369-377 Kentish Town Road

Design Statement

September 2024

This document sets out proposed design updates to the approved scheme at 369-377 Kentish Town Road. The original consent was for a seven story (G+6) building with 14 residential apartments, and Class E (retail) use at ground and basement floor. Planning permission was granted for the scheme in 2020 - application ref: 2019/0910/P.

First Floor Plan

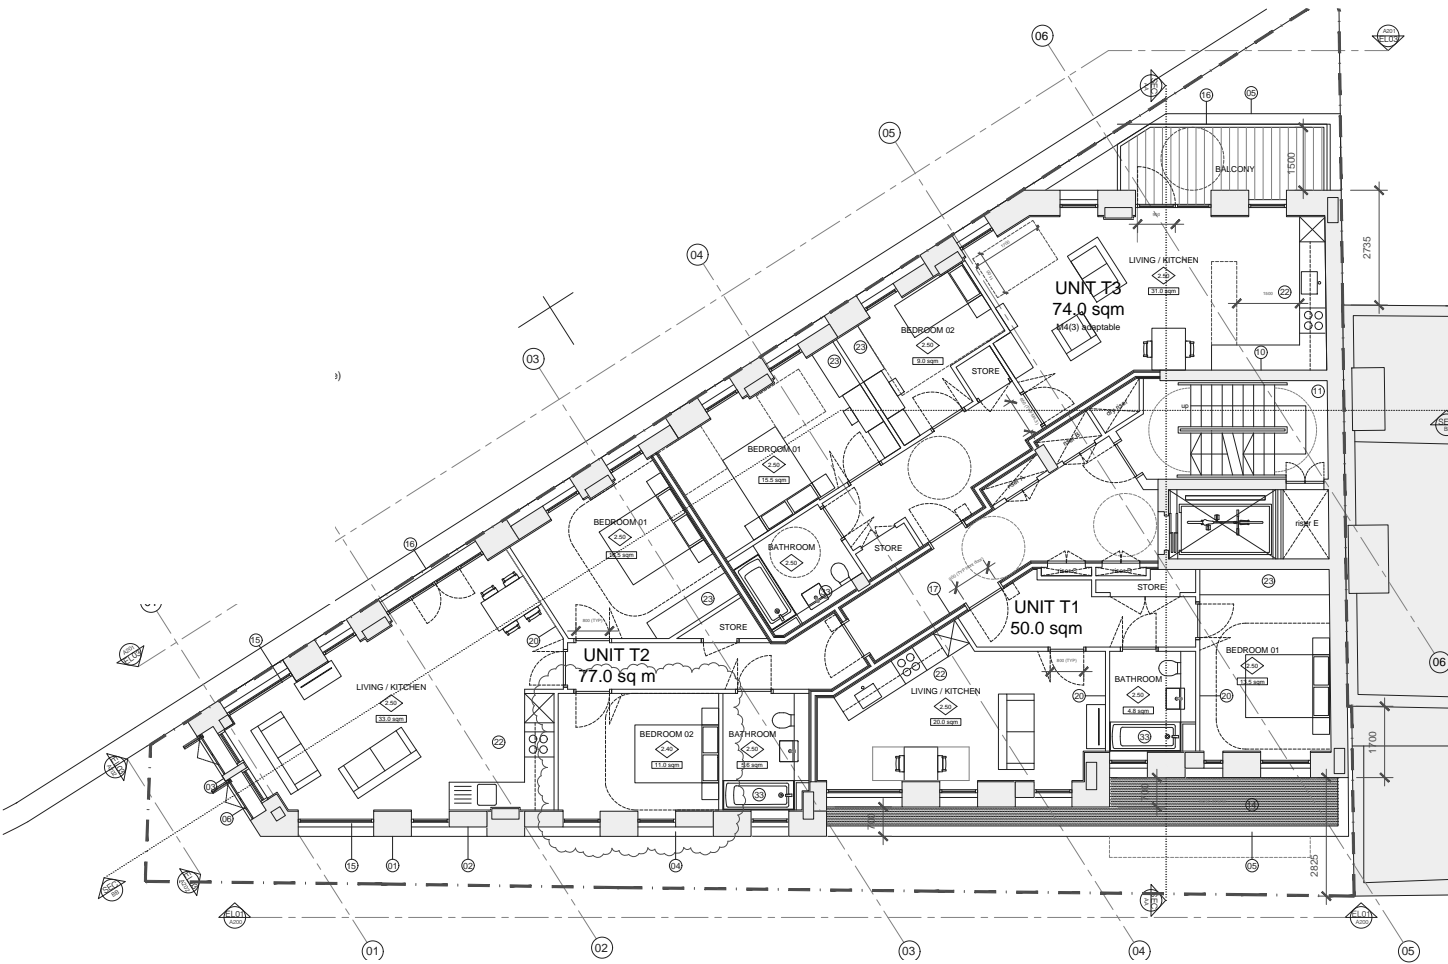
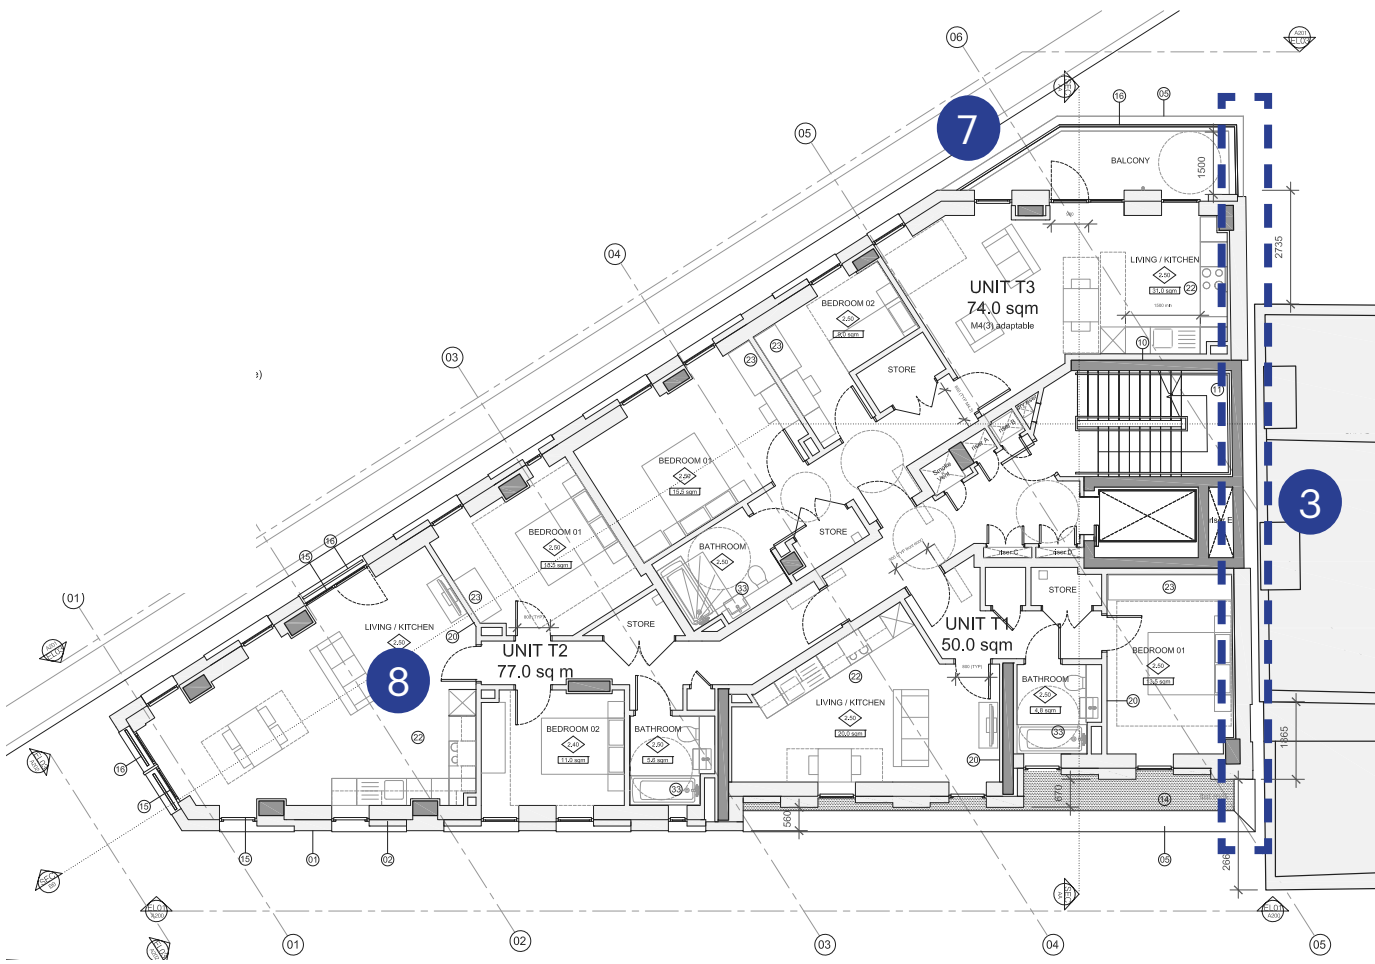
- Plan Updates:
- 3. Party wall moved 150mm away from site boundary due to site tolerances with existing building adjacent.
 - 7. Layout of balcony updated to allow for safe cleaning and maintenance.
 - 8. Minor amendments to improve internal layout.

Second Floor Plan

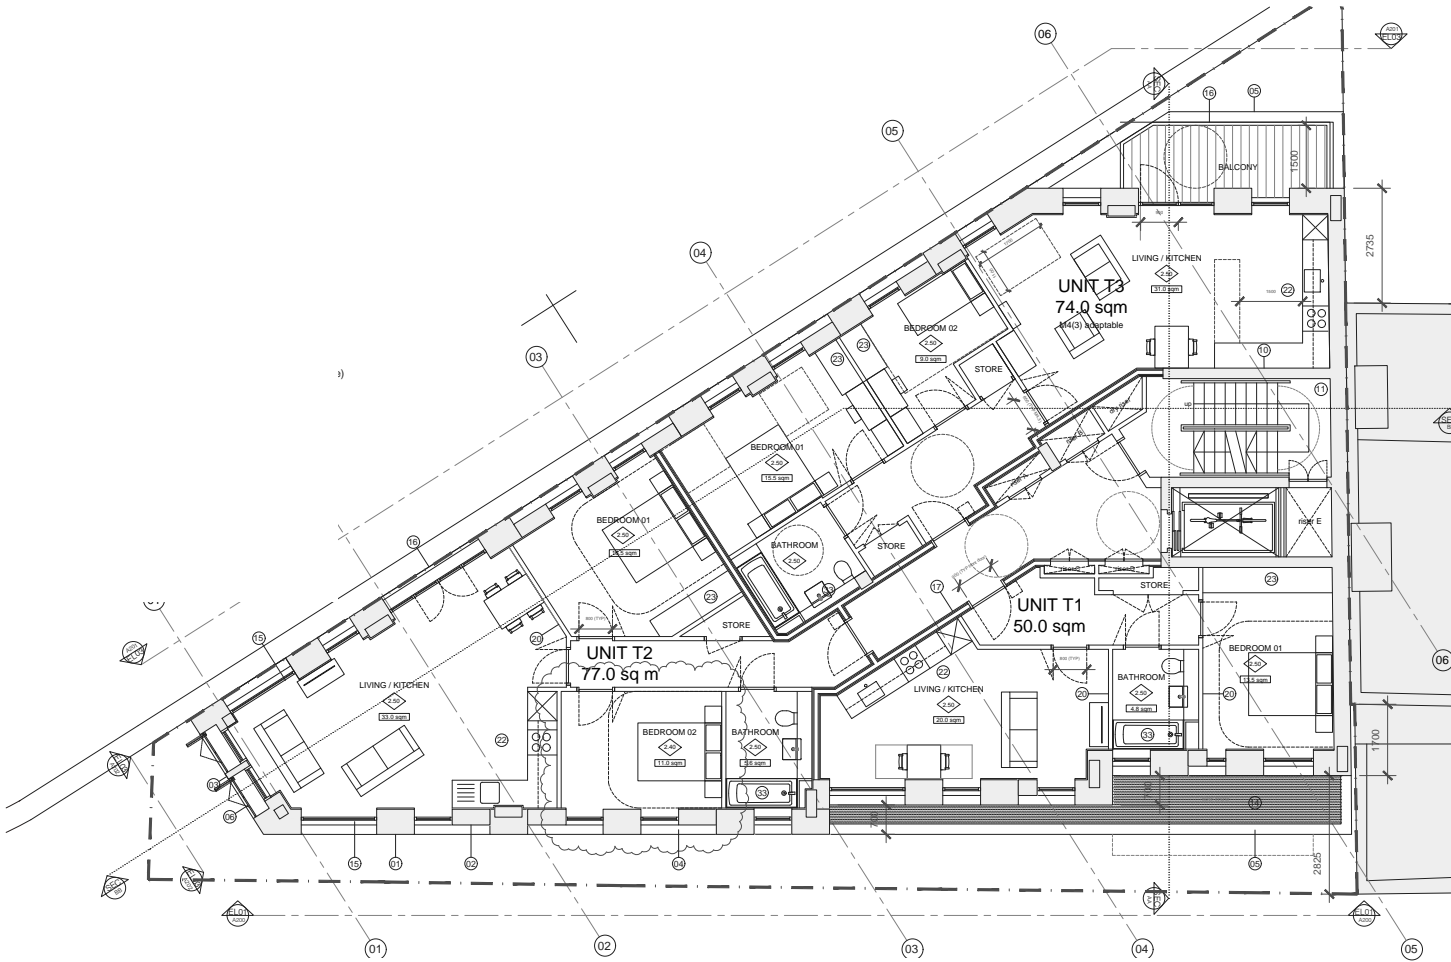
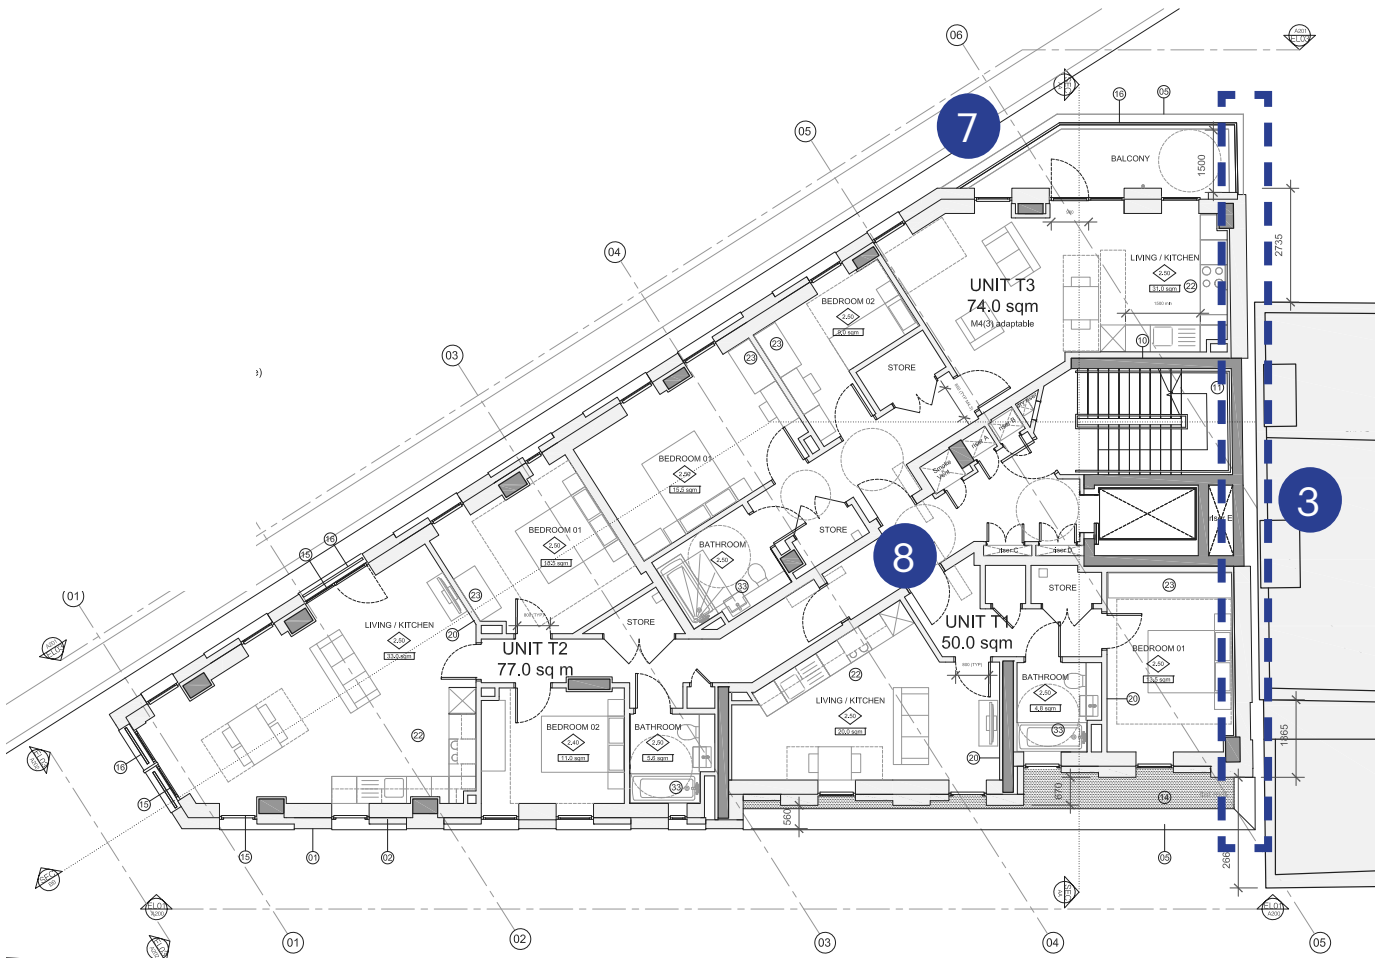
- Plan Updates:
- 3. Party wall moved 150mm away from site boundary due to site tolerances with existing building adjacent.
 - 7. Layout of balcony updated to allow for safe cleaning and maintenance.
 - 8. Minor amendments to improve internal layout.

Third Floor Plan

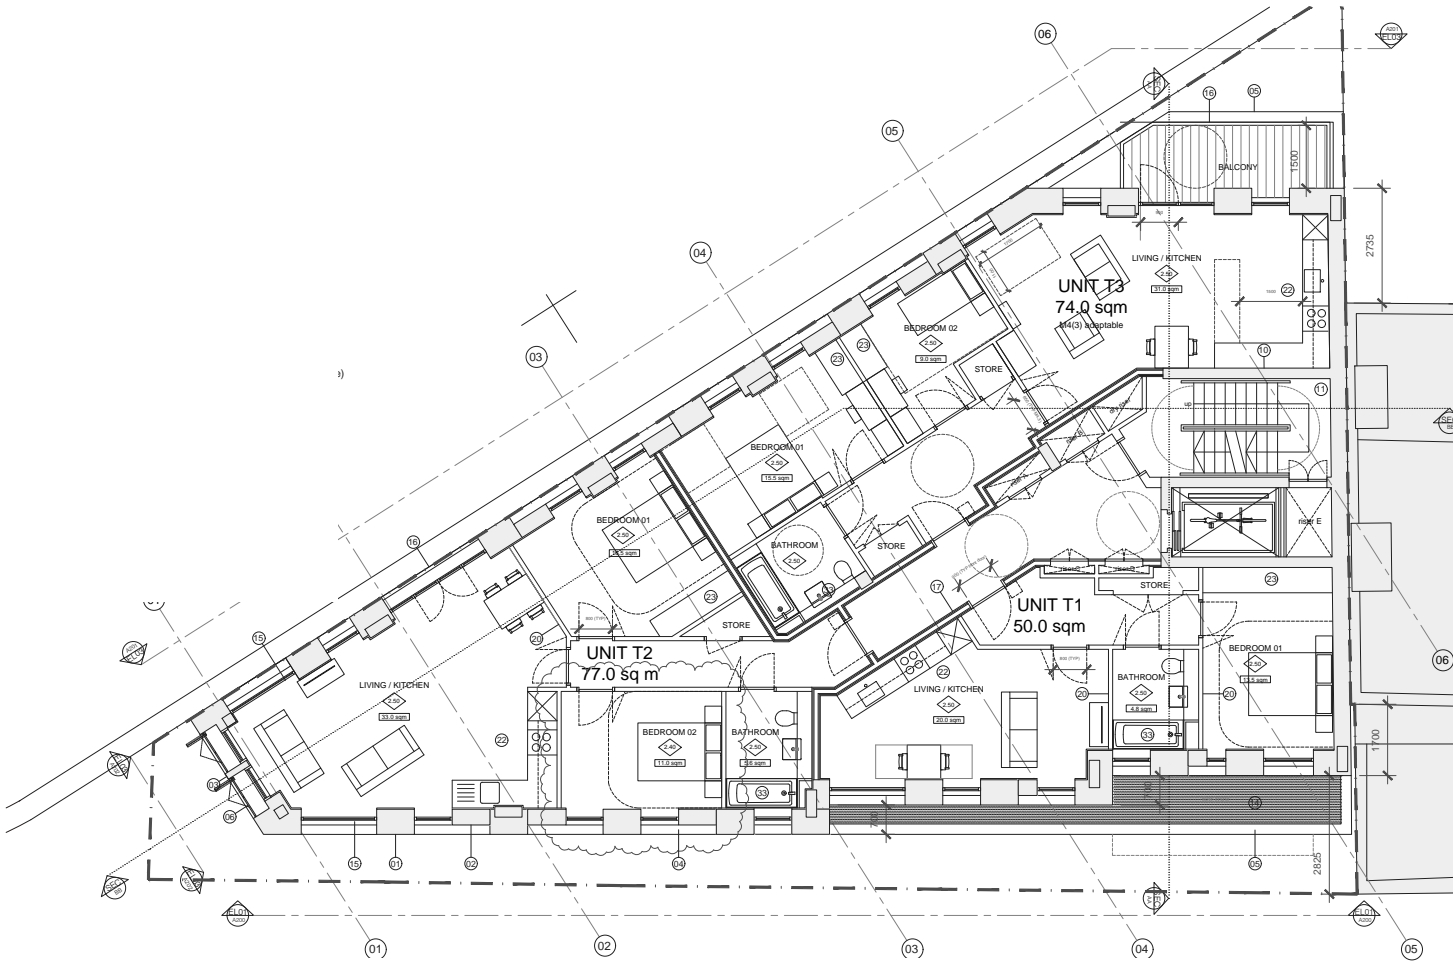
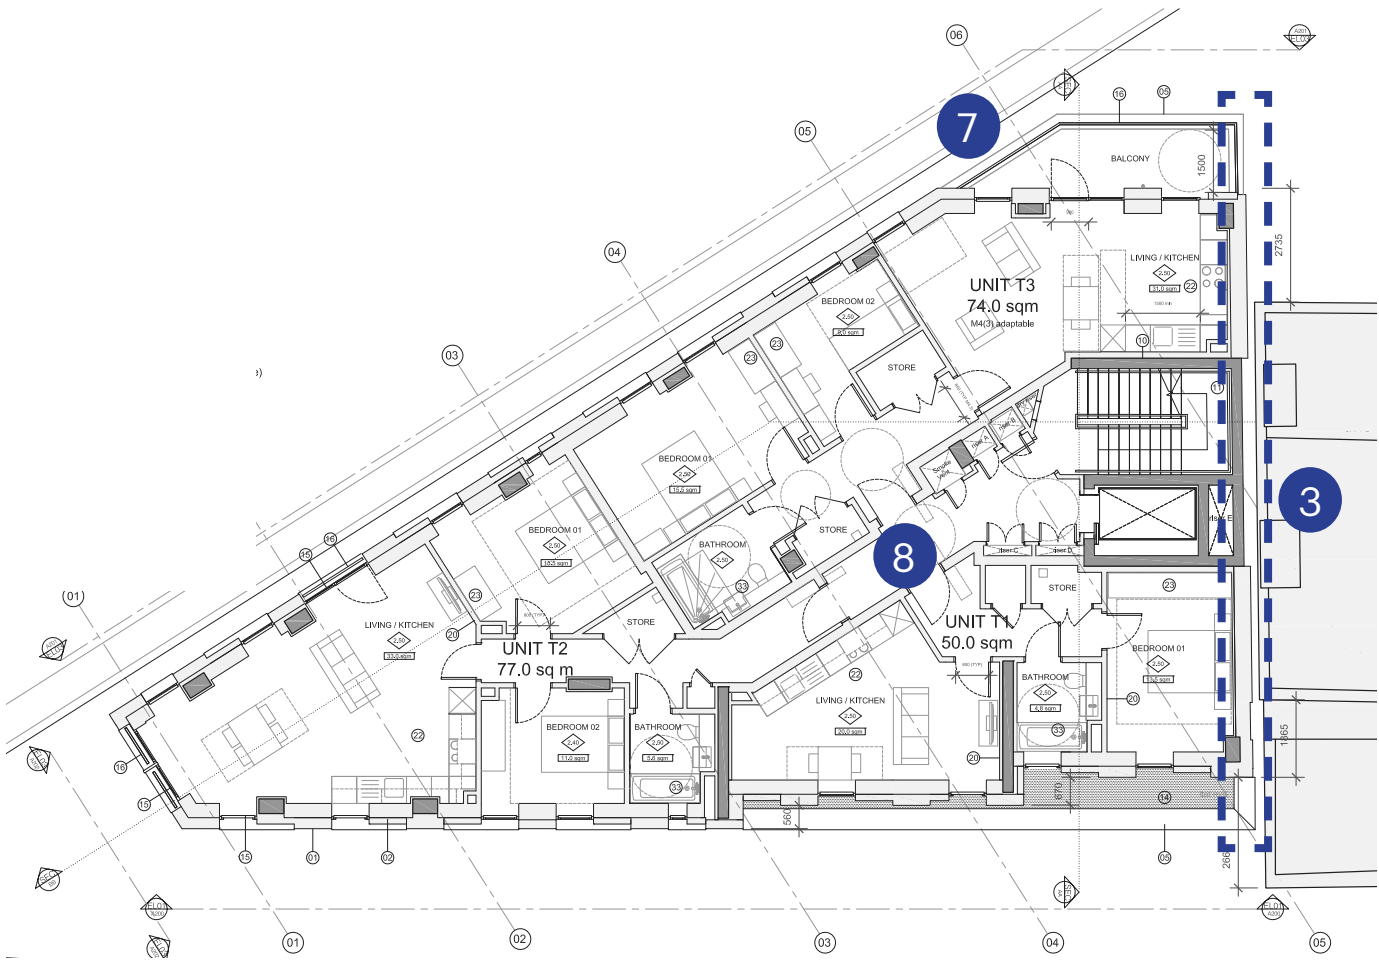
- Plan Updates:
- 3. Party wall moved 150mm away from site boundary due to site tolerances with existing building adjacent.
 - 7. Layout of balcony updated to allow for safe cleaning and maintenance.
 - 8. Minor amendments to improve internal layout.

Fourth Floor Plan

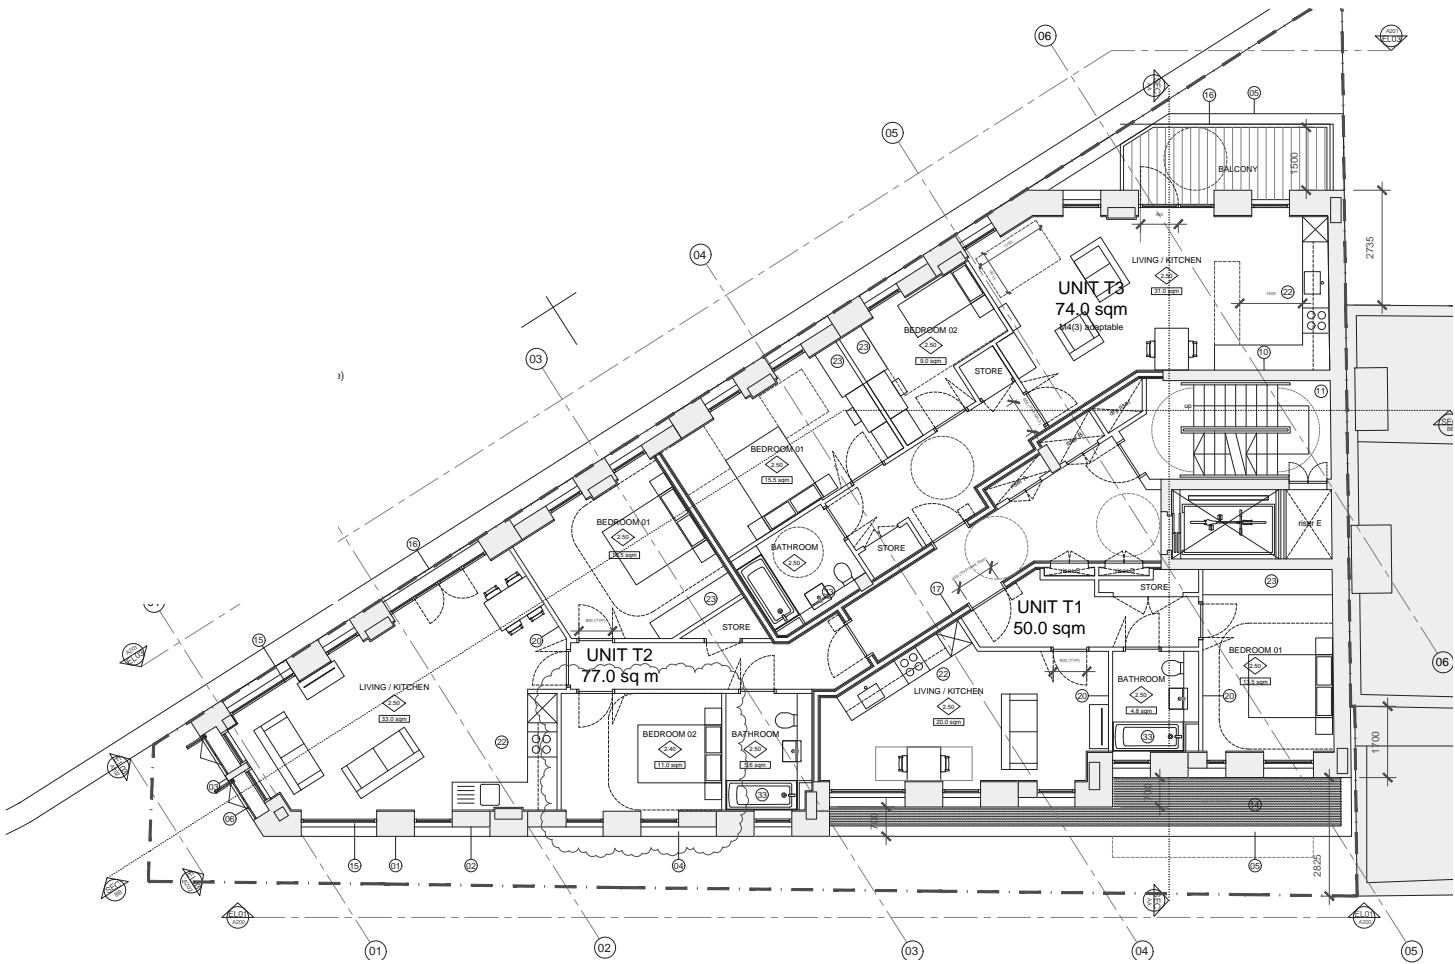
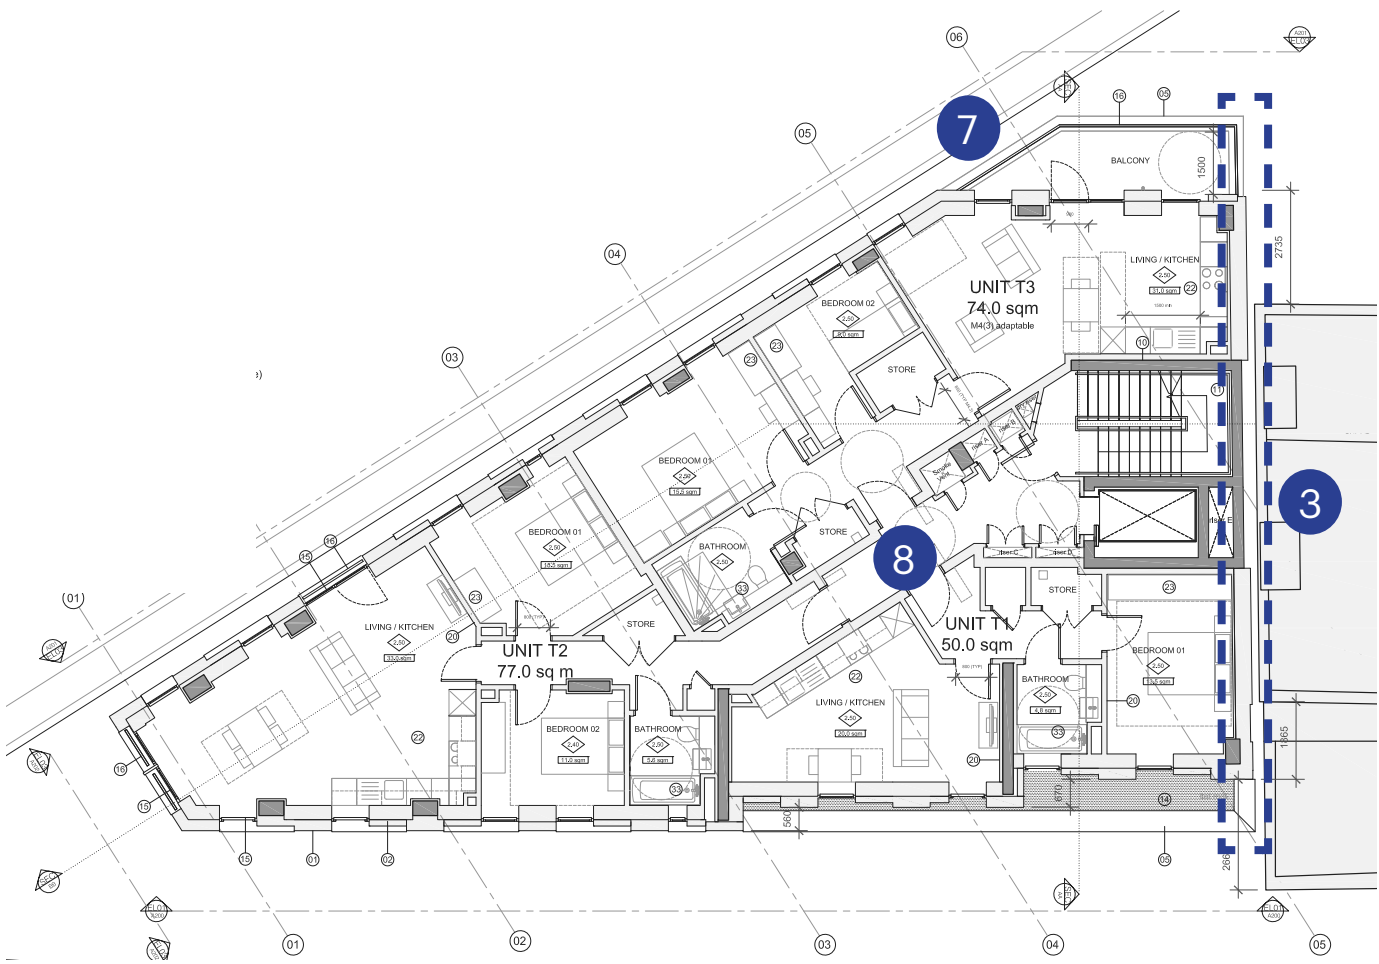
- Plan Updates:
- 3. Party wall moved 150mm away from site boundary due to site tolerances with existing building adjacent.
 - 7. Layout of balcony updated to allow for safe cleaning and maintenance.
 - 8. Minor amendments to improve internal layout.
